**THE IMPROVEMENTS OF
PROCTOR ROAD
FROM REDWOOD ROAD TO CAMONO ALTA MIRA
CASTRO VALLEY, ALAMRDA COUNTY, CALIFORNIA
SPECIFICATION NO. 2491**

This addendum is issued by the County of Alameda, Public Works Agency, Construction and Development Services Department, 399 Elmhurst Street, Hayward, CA 94544.

Receipt of this Addendum No. 1 must be acknowledged on the form in the bid proposal in writing.

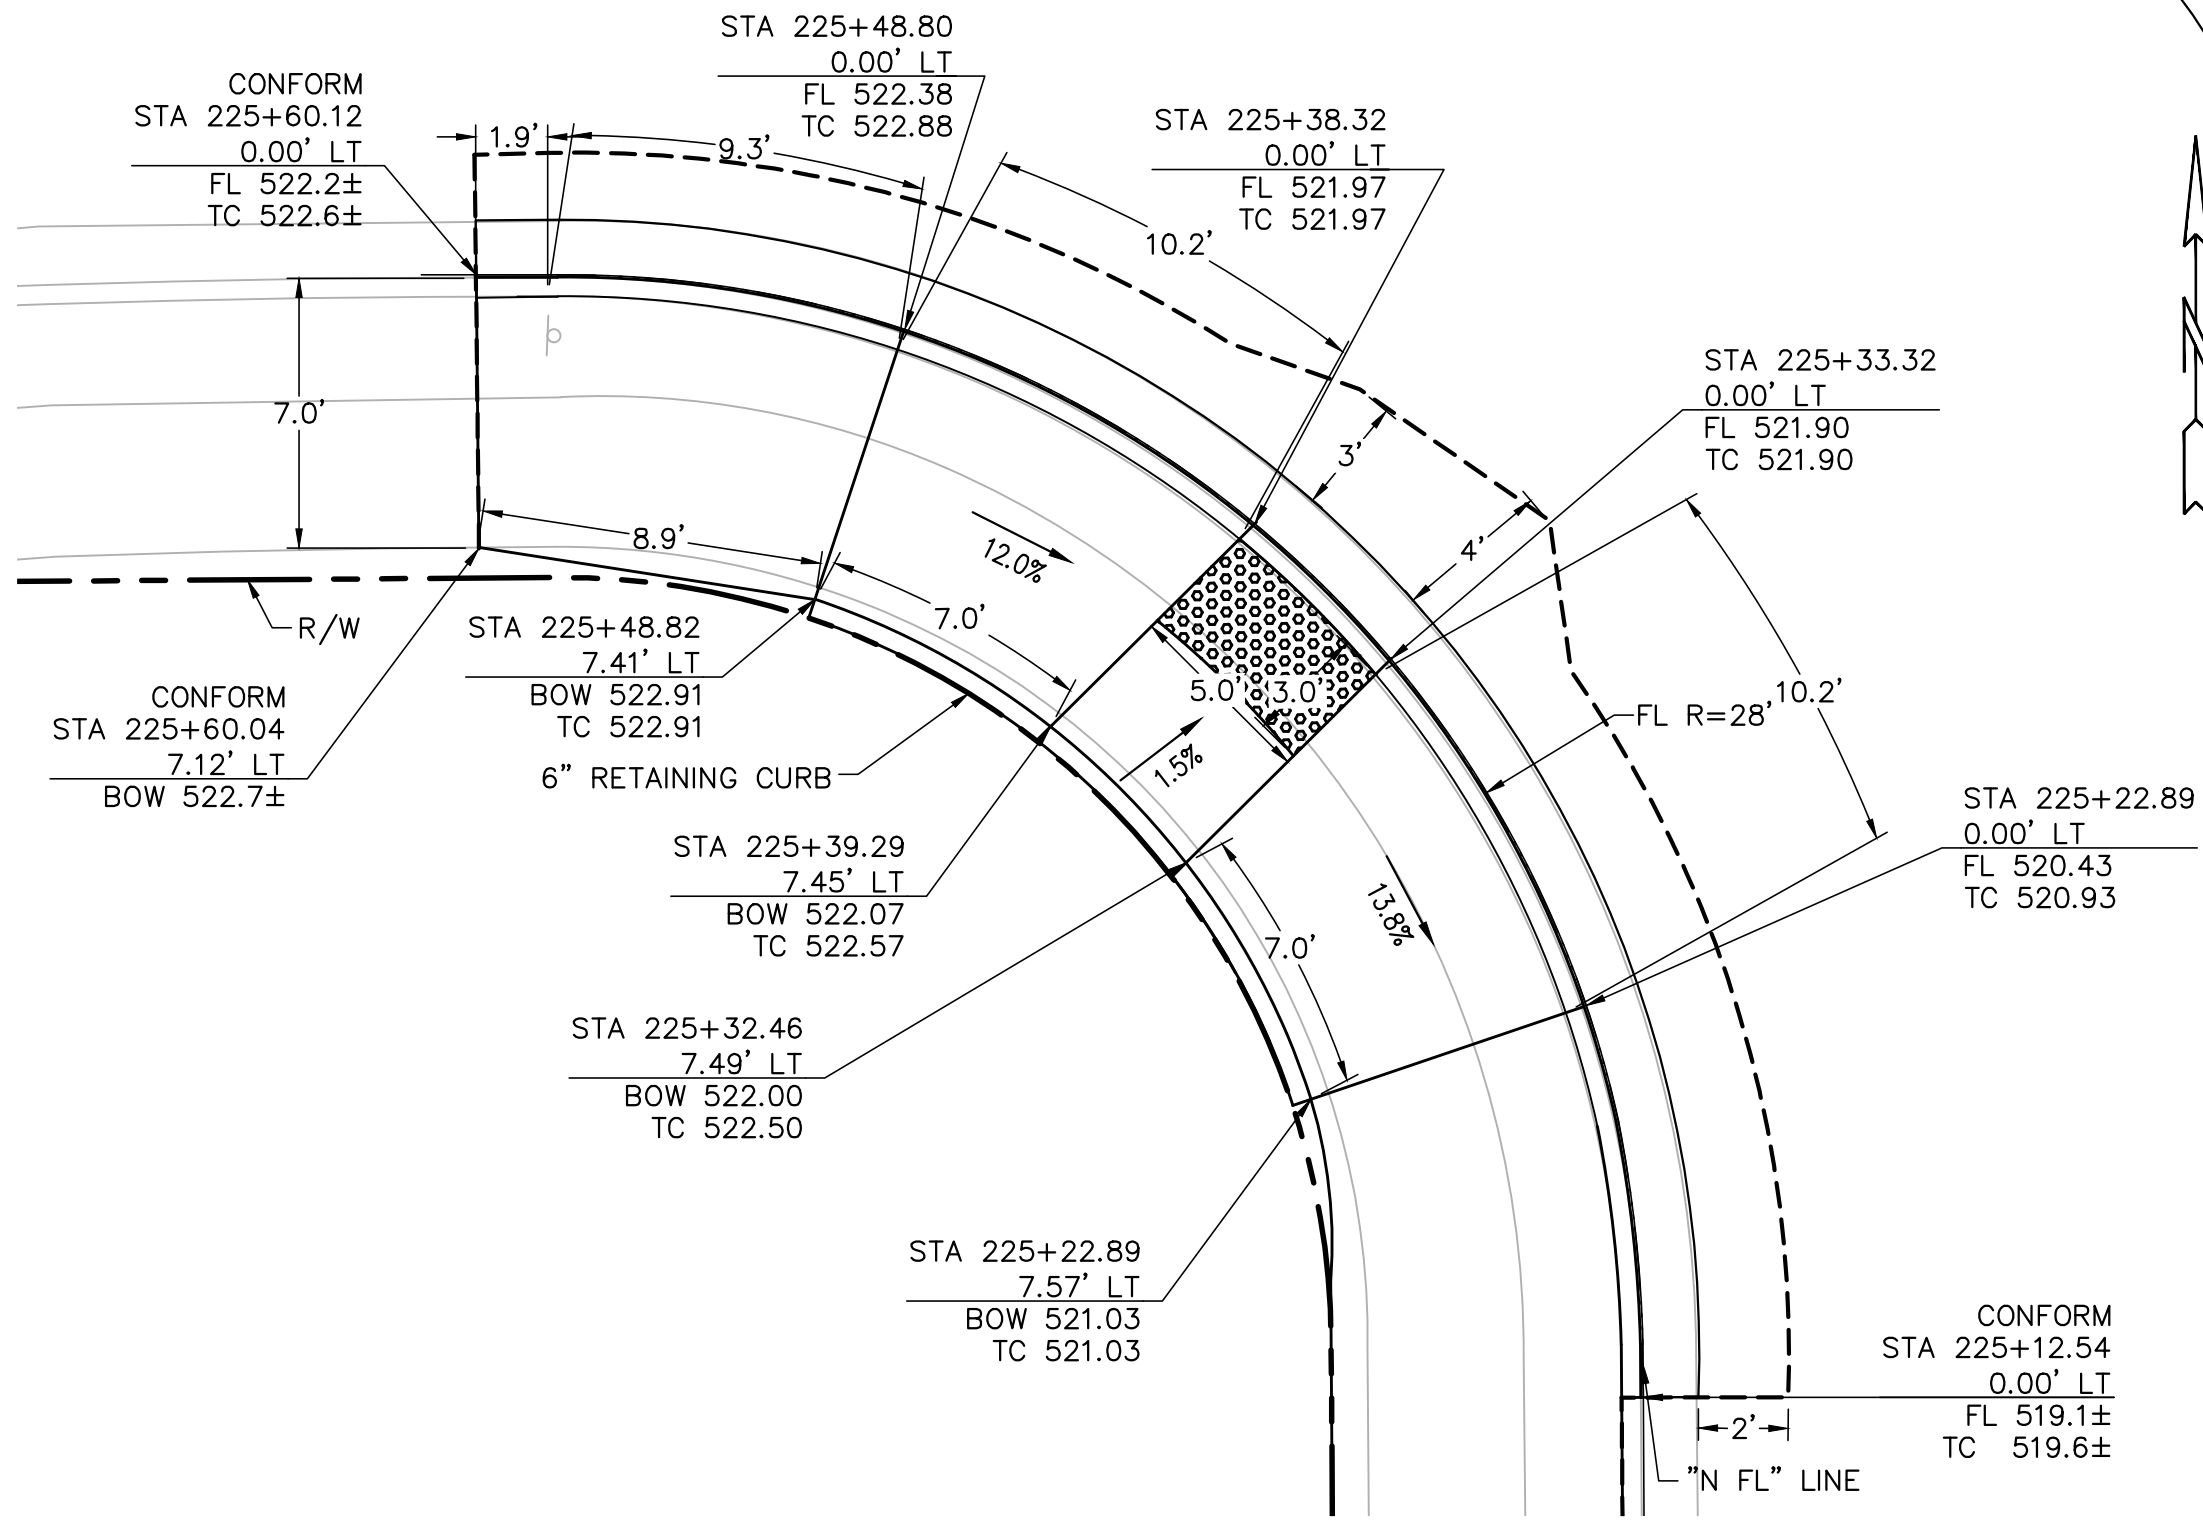
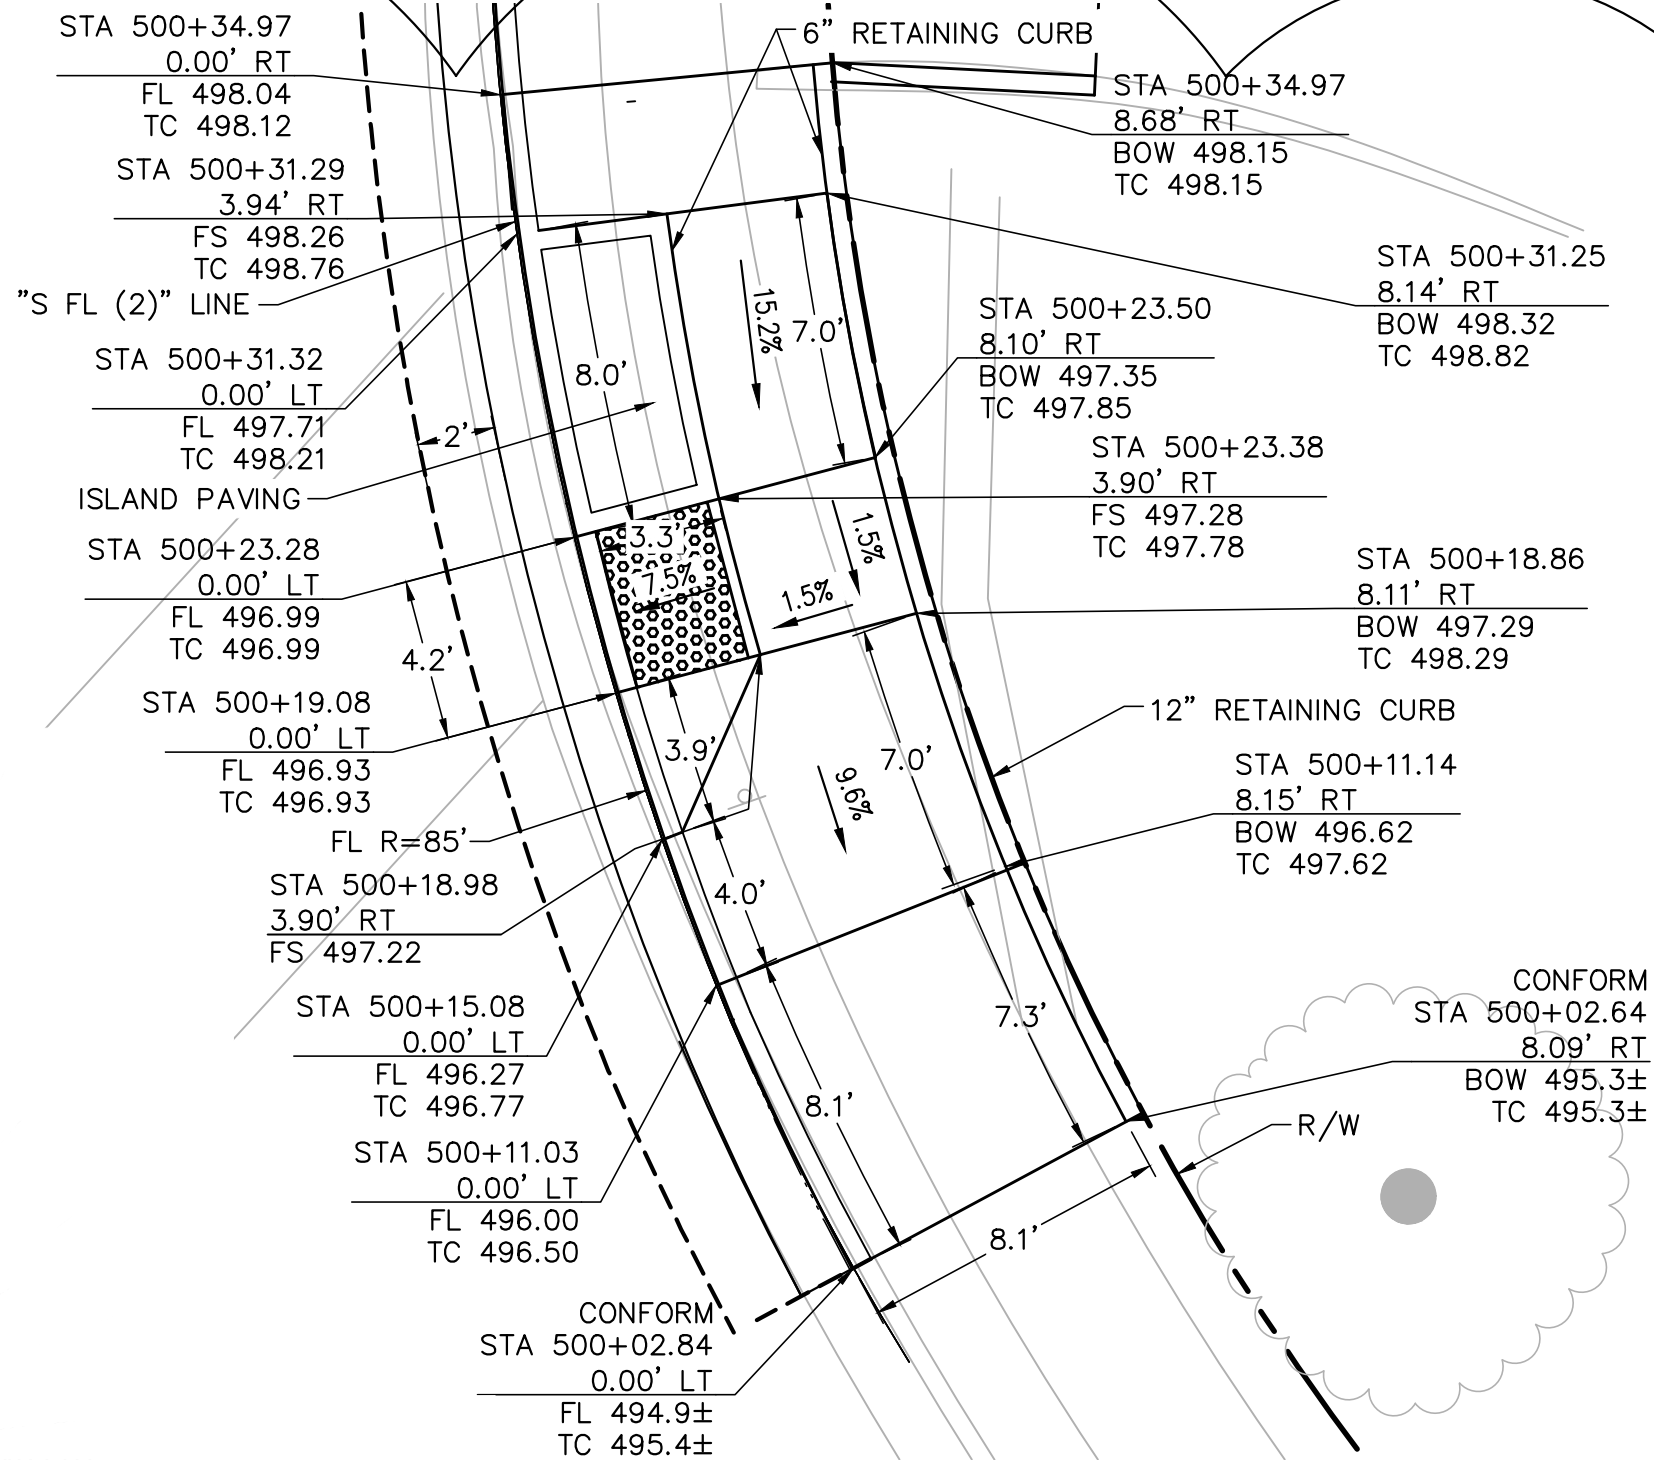
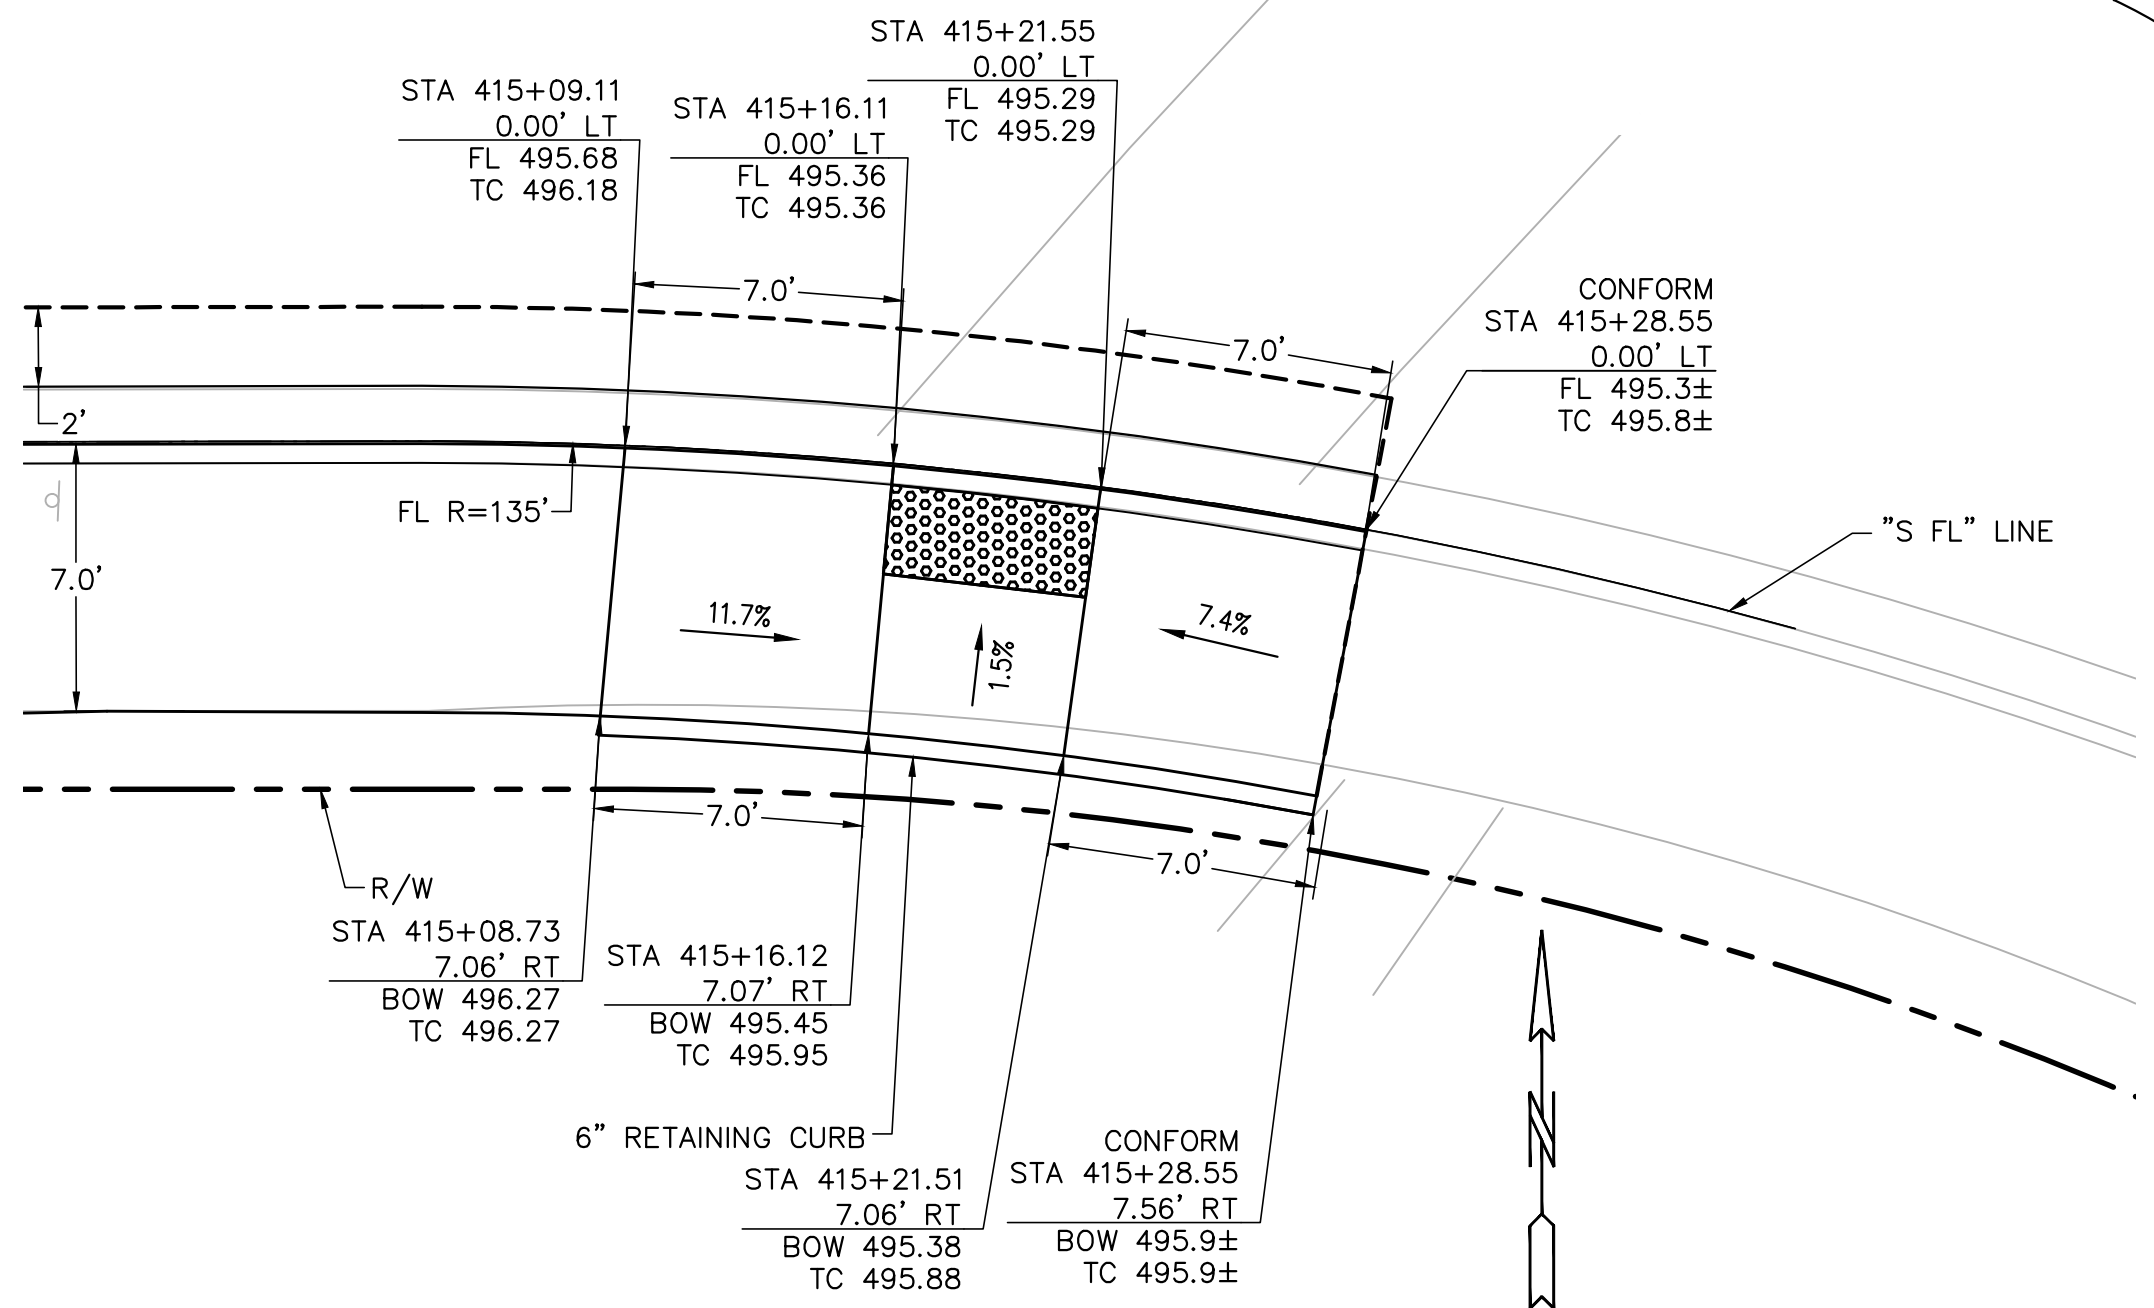
COUNTY OF ALAMEDA ☆ PUBLIC WORKS AGENCY				REVISIONS			
THE IMPROVEMENTS OF PROCTOR ROAD FROM REDWOOD ROAD TO CAMINO ALTA MIRA				NO.	DESCRIPTION	BY	DATE
CONSTRUCTION DETAILS				NO.	REVISD CURB RAMP DETAILS	JK	4/8/25
U-639				NO.	APPROVAL	BY	DATE
DATE: MAR 2025				APPROVAL			
WORK ORDER NO. R32144				APPROVAL			
SPECIFICATION NO. 2491				APPROVAL			
SHEET NO. 38 OF 59				APPROVAL			
FILE NO.				APPROVAL			
U-639				APPROVAL			
REVIEWED: EMANUEL KASERNE				APPROVAL			
DESIGNED: AMBER K. LO				APPROVAL			
DRAWN: JACOBSON KRAVETS				APPROVAL			
CHECKED: CAROLYN DAVIS				APPROVAL			
244 Thomas L. Braylor Way Oakland, California 94612				APPROVAL			
(415) 543-8515				APPROVAL			
PROFESSIONAL ENGINEER JAMES CLEMENTS No. C47157				APPROVAL			
DATE OF CALCULATION				APPROVAL			
APPROVAL DATE: 03-07-25				APPROVAL
